Contract No. T200411209.01
Federal Aid Project No. ESTP-S028(8)
SR 24, Mulberry Knoll to SR 1
Sussex County

Enclosed is Addendum No. 1 for the referenced contract consisting of the following:

Addendum No. 1
October 24, 2019

STORMWATER MANAGEMENT PLAN DELDOT SWM FACILITY ~~#2~~ #1026 △1

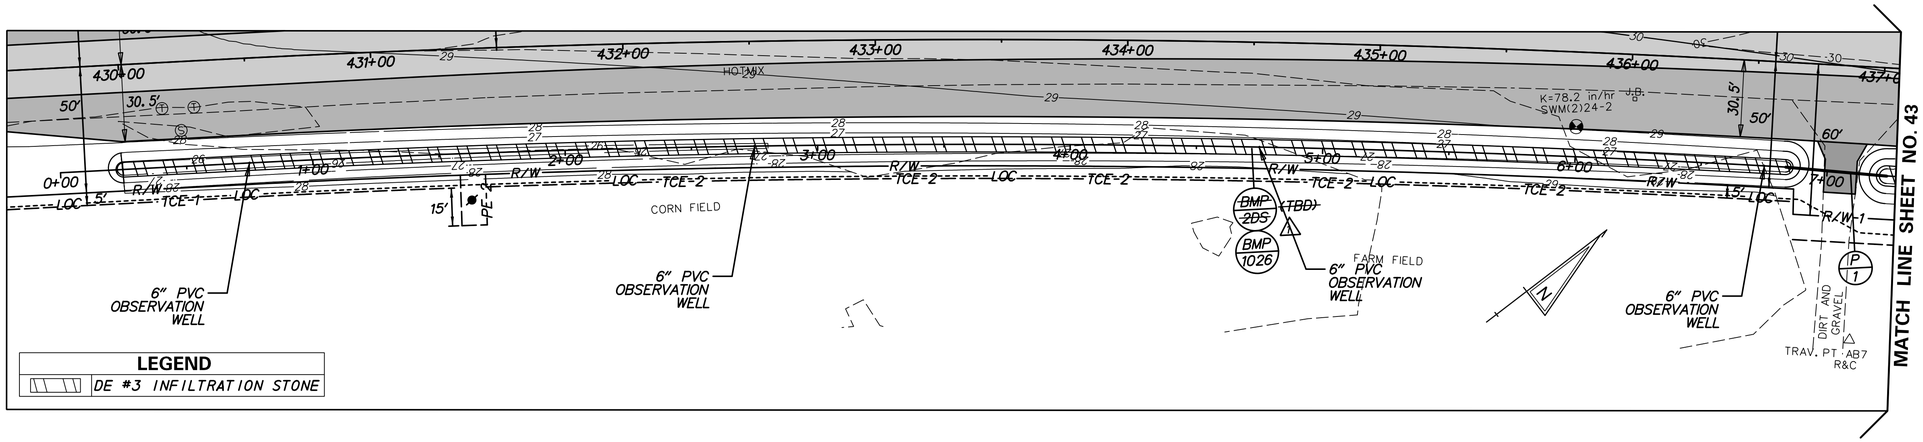
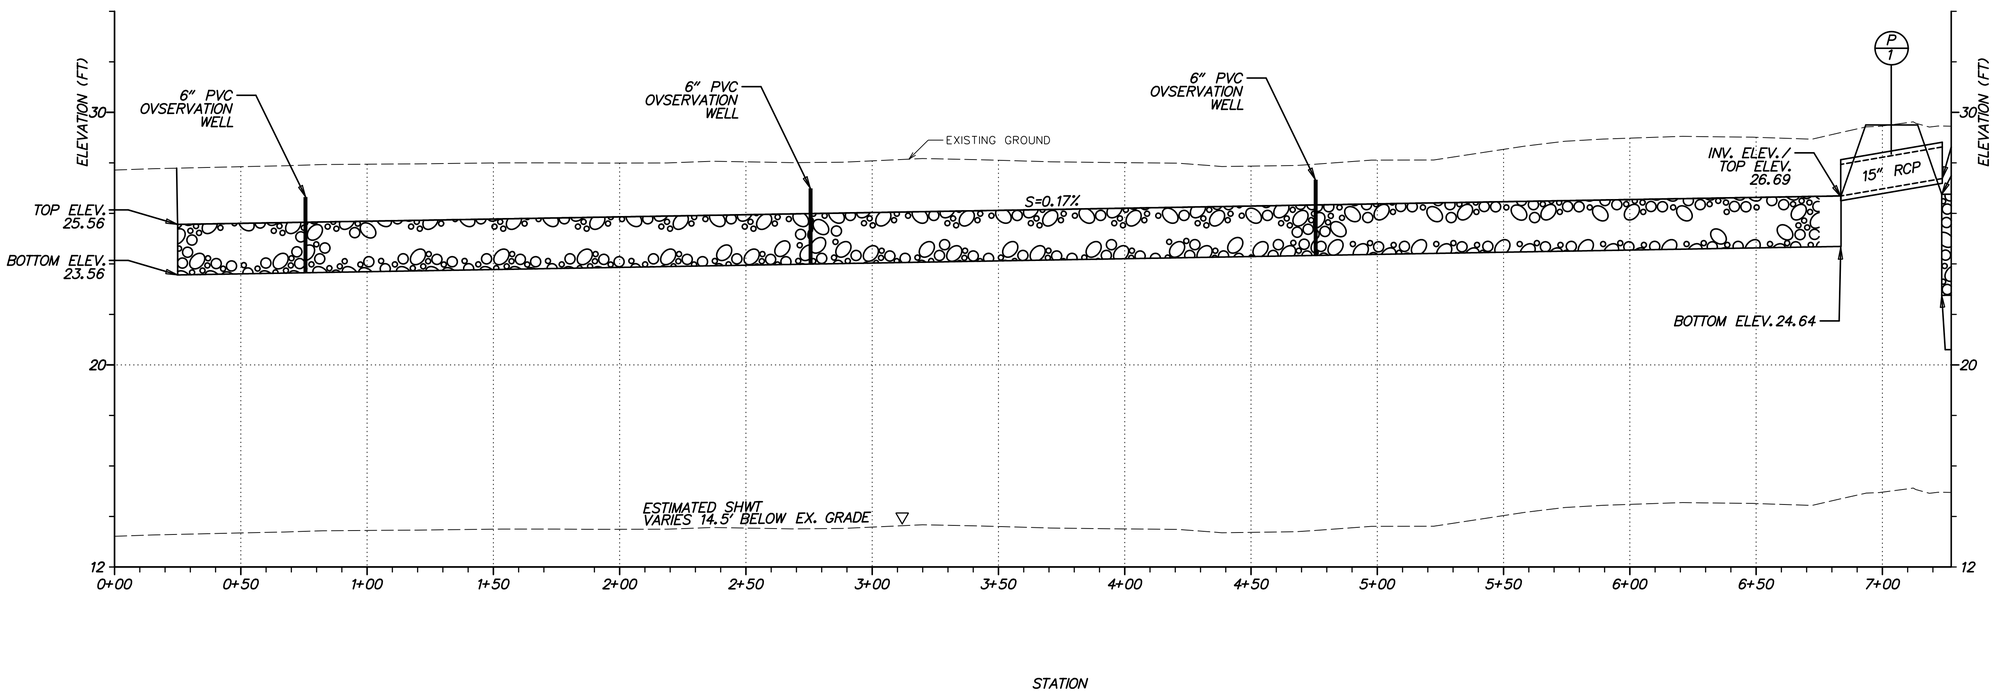
PLAN – INFILTRATION TRENCH – BMP ~~NO. 2-DS (TBD)~~ NO. 1026 △1

PROFILE – INFILTRATION TRENCH – BMP ~~NO. 2-DS (TBD)~~ NO. 1026 △1

STORMWATER MANAGEMENT PLAN DELDOT SWM FACILITY ~~#2~~ #1025 △1

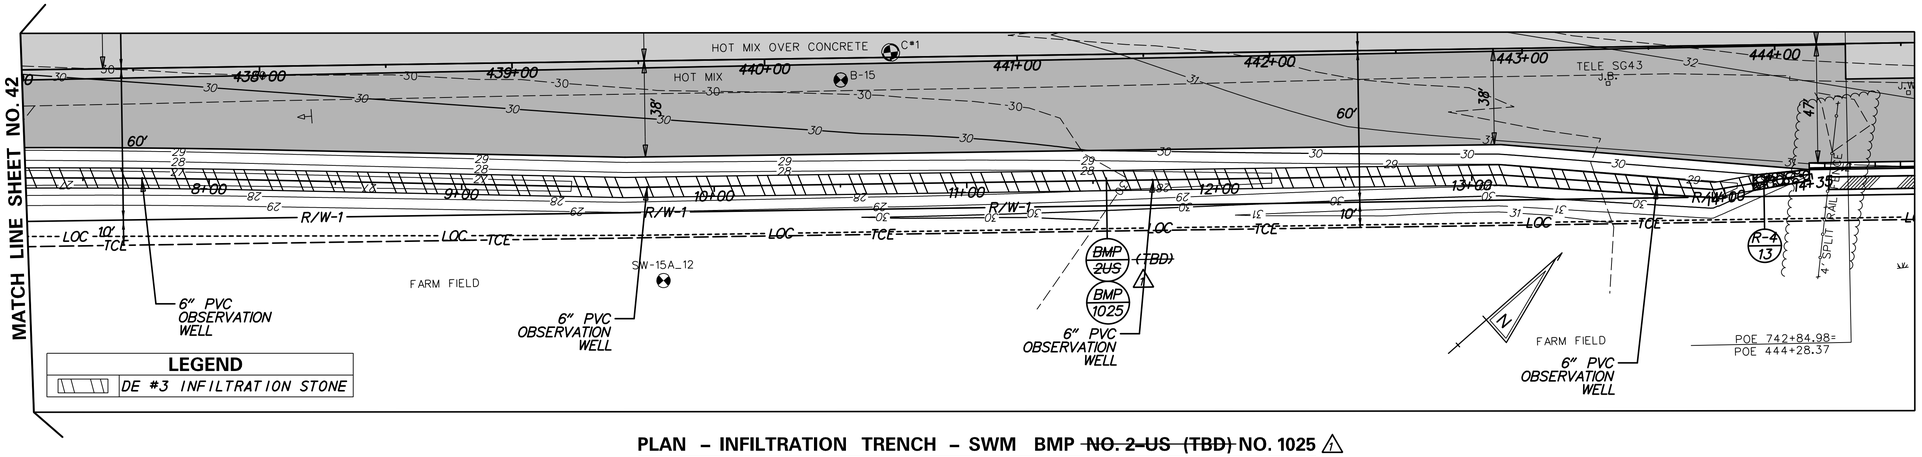
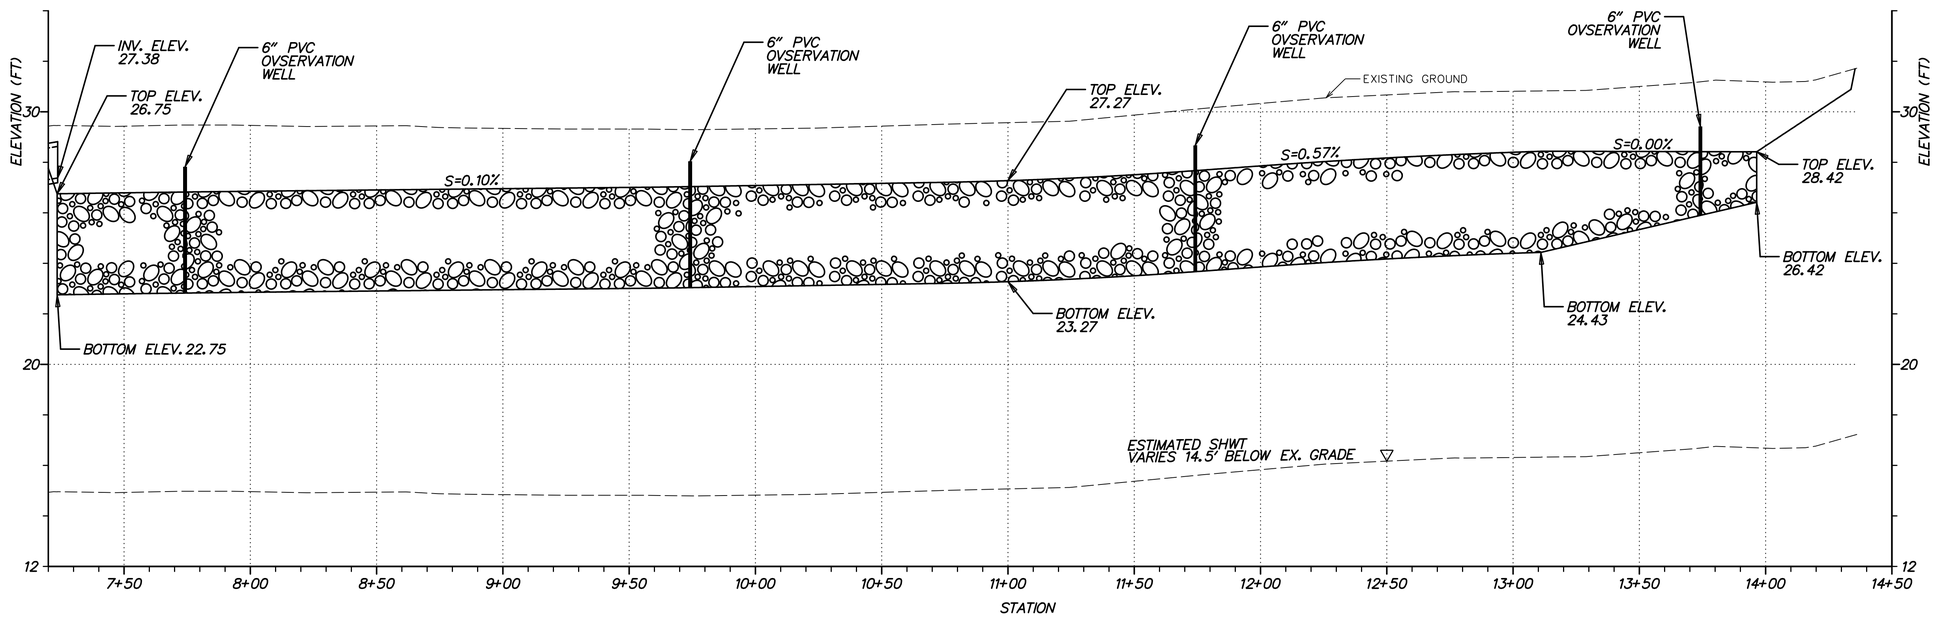
PLAN – INFILTRATION TRENCH – SWM BMP ~~NO. 2-US (TBD)~~ NO. 1025 △1

PROFILE – INFILTRATION TRENCH – SWM BMP ~~NO. 2-US (TBD)~~ NO. 1025 △1

STORMWATER MANAGEMENT PLAN DELDOT SWM FACILITY ~~#4-BS~~ #1024 △1

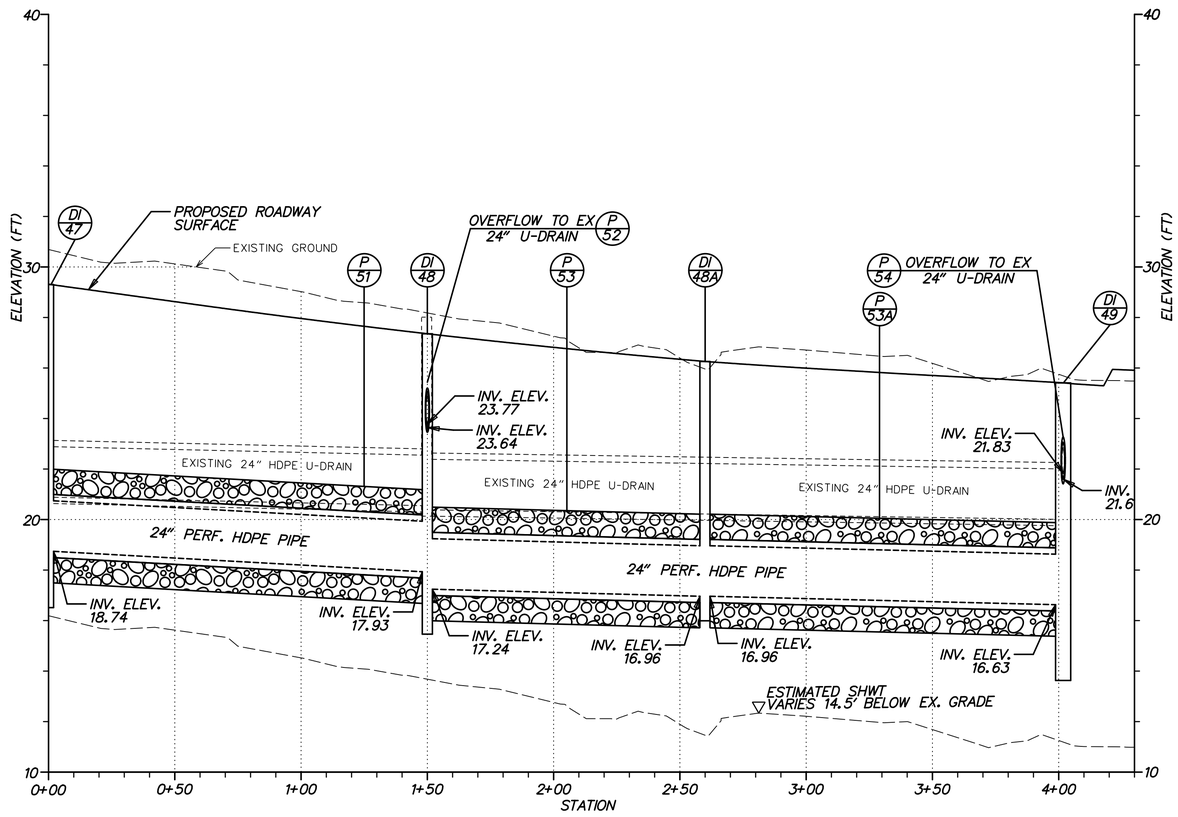
PLAN – INFILTRATION TRENCH – SWM BMP ~~NO.4-BS (TBD)~~ NO. 1024 △1

PROFILE – INFILTRATION TRENCH – SWM BMP ~~NO.4-BS (TBD)~~ NO. 1024 △1

STORMWATER MANAGEMENT PLAN DELDOT SWM FACILITY ~~#4-AS~~ #1023 △1

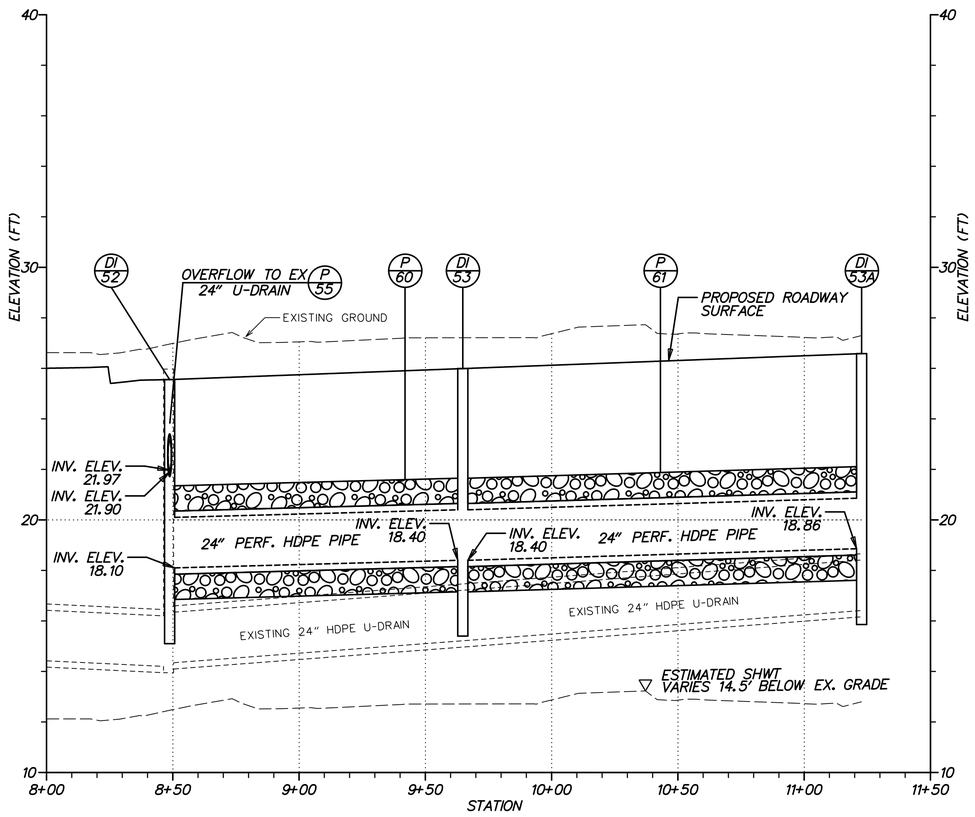
PLAN – INFILTRATION TRENCH – SWM BMP ~~NO.4-AS (TBD)~~ NO. 1023 △1

PROFILE – INFILTRATION TRENCH – SWM BMP ~~NO.4-AS (TBD)~~ NO. 1023 △1

STORMWATER MANAGEMENT PLAN DELDOT SWM FACILITY ~~#6~~ #1021 △1

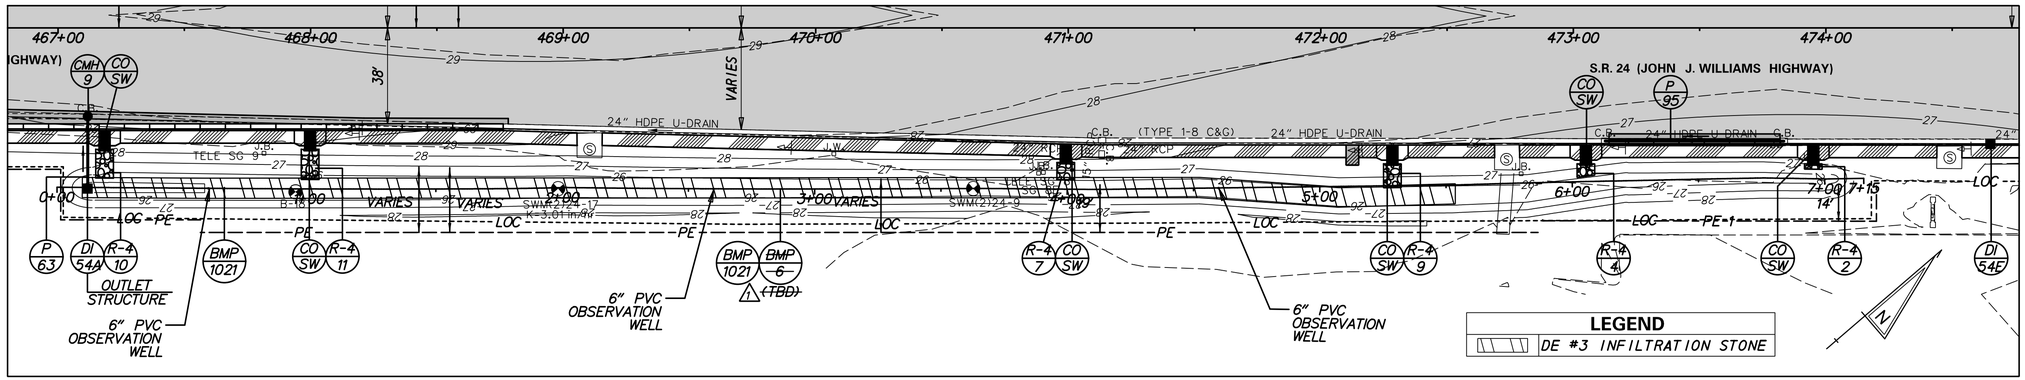
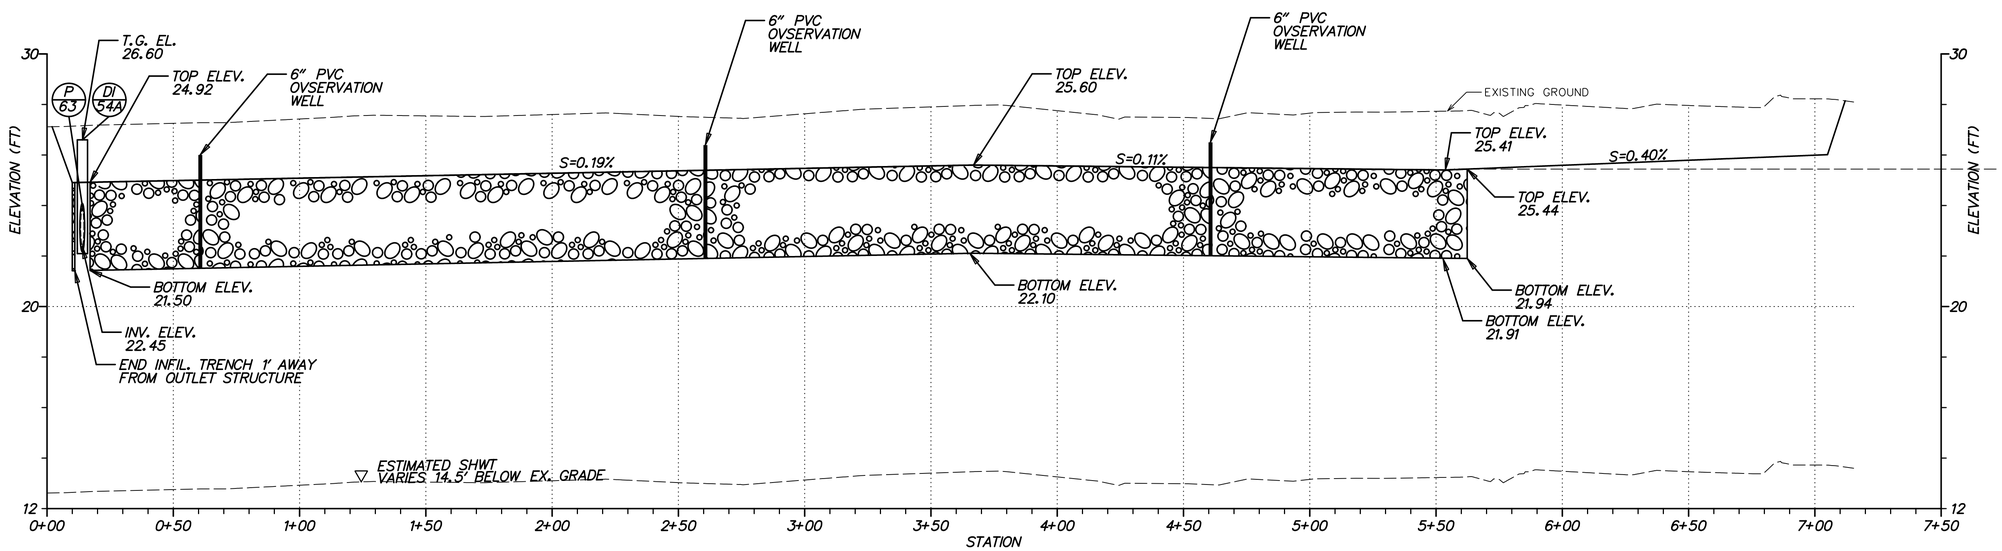
PLAN – INFILTRATION TRENCH – SWM BMP ~~NO.6 (TBD)~~ NO. 1021 △1

PROFILE – INFILTRATION TRENCH – SWM BMP ~~NO.6 (TBD)~~ NO. 1021 △1
